Department of Planning and Zoning

TO: Development Review Board
FROM: Scott Gustin
DATE: October 7, 2014
RE: 15-0055CA; 15 Conger Avenue

Request: Replace existing garage with new single family dwelling.

SITE PLAN PROPOSED RESIDENCE 15-19 CONCORD AVE
 FIRST FLOOR PLAN DATE 9.7.14/8.28.14
 SCALE: 1/4" = 1'-0"

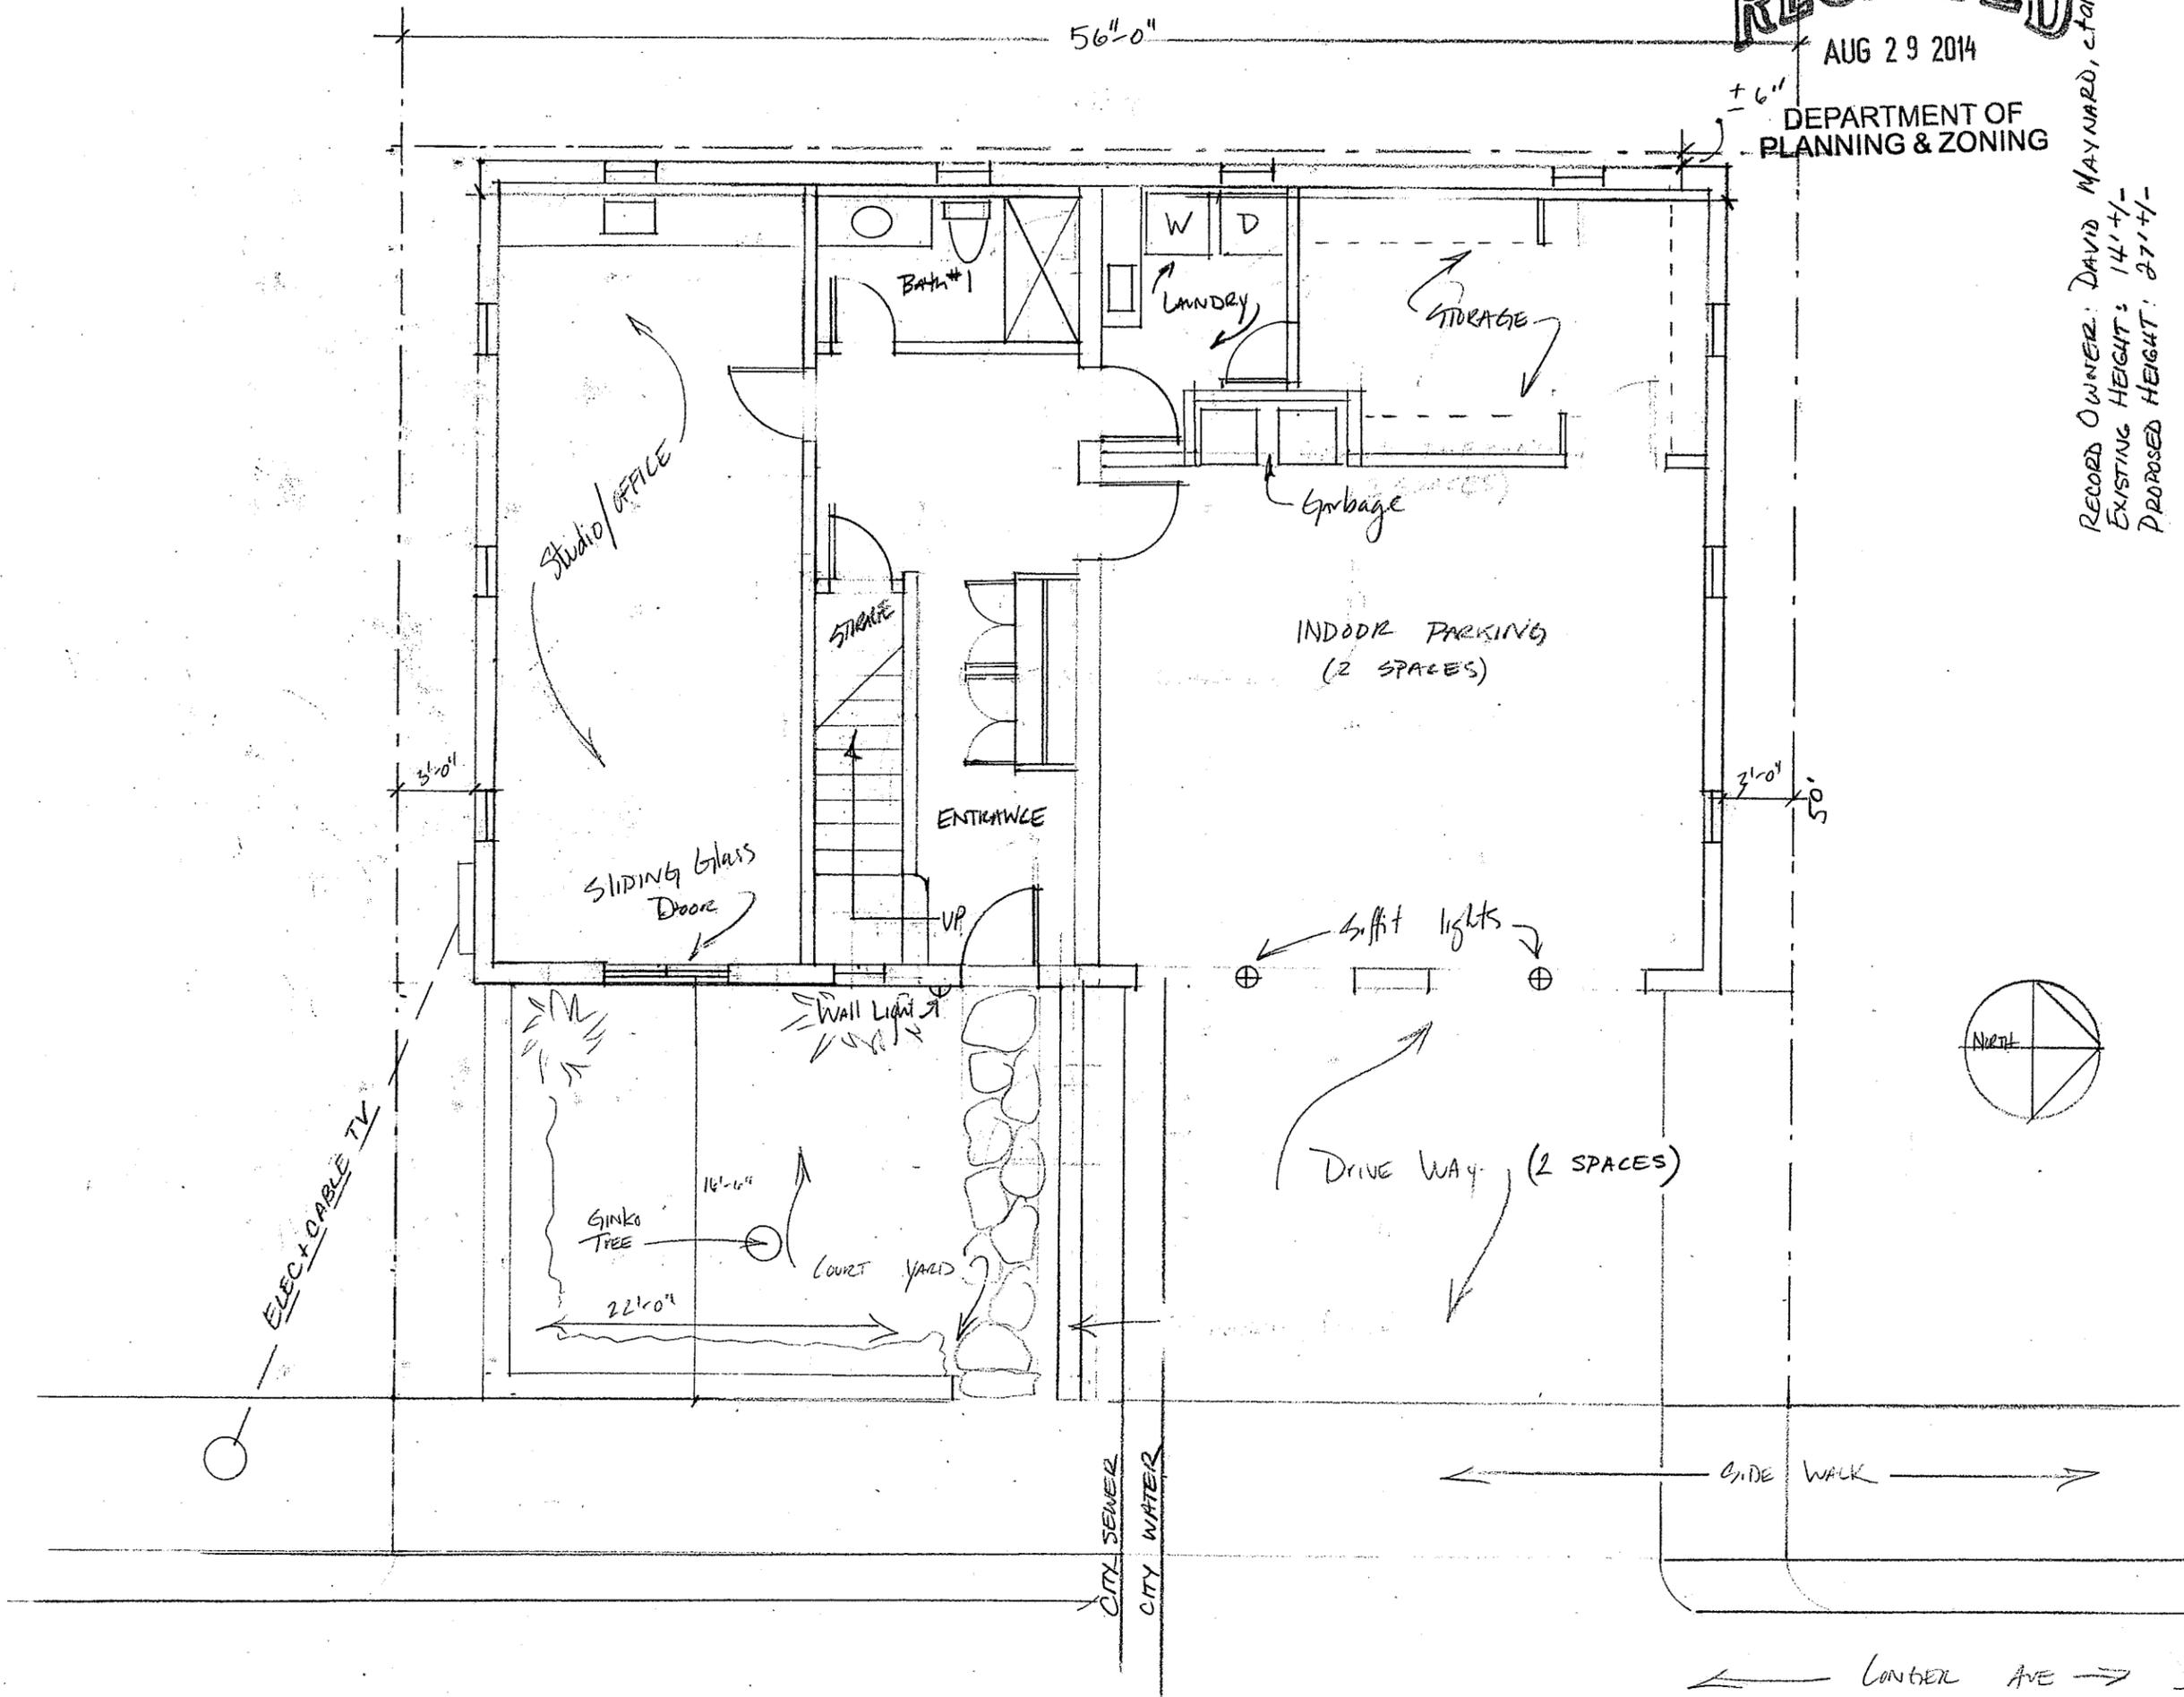
The garage presently contains four overhead doors facing Conger Avenue. The new home will contain two overhead doors facing the street. A single driveway will lead to these two garage doors. The driveway is 20' wide and exceeds the 18' maximum width. As recommended by the DAB, it must be narrowed accordingly (it may flare up to 20' by the garage entries, lot coverage problems notwithstanding). In light of lot coverage limitations, a strip driveway up to the garage doors may be the most appropriate option. As presented, the driveway is not permissible. **(Adverse finding)**

Lot coverage problems notwithstanding, the proposed parking and circulation arrangement is simple. A short, straight driveway would connect the 2-bay garage to the street. The 2 required parking spaces would be contained within the garage. As noted above, the driveway cannot exceed 18' width. In light of lot coverage limitations, a strip driveway coupled with a reduced building footprint may be the most appropriate option. As presented, the driveway is unacceptable. **(Adverse finding)**

Any new utility lines must be buried. The site plan depicts a utility meter on the south side of the building. The south building elevation does not depict the utility meter. As recommended by the DAB, the utility meter must be depicted and screened. See also Sec. 6.3.2 (h) below. **(Affirmative finding if conditioned)**

1. Revise the driveway to no more than 18' wide.
2. Note the proposed fence as wooden.
3. Screen the utility meters.
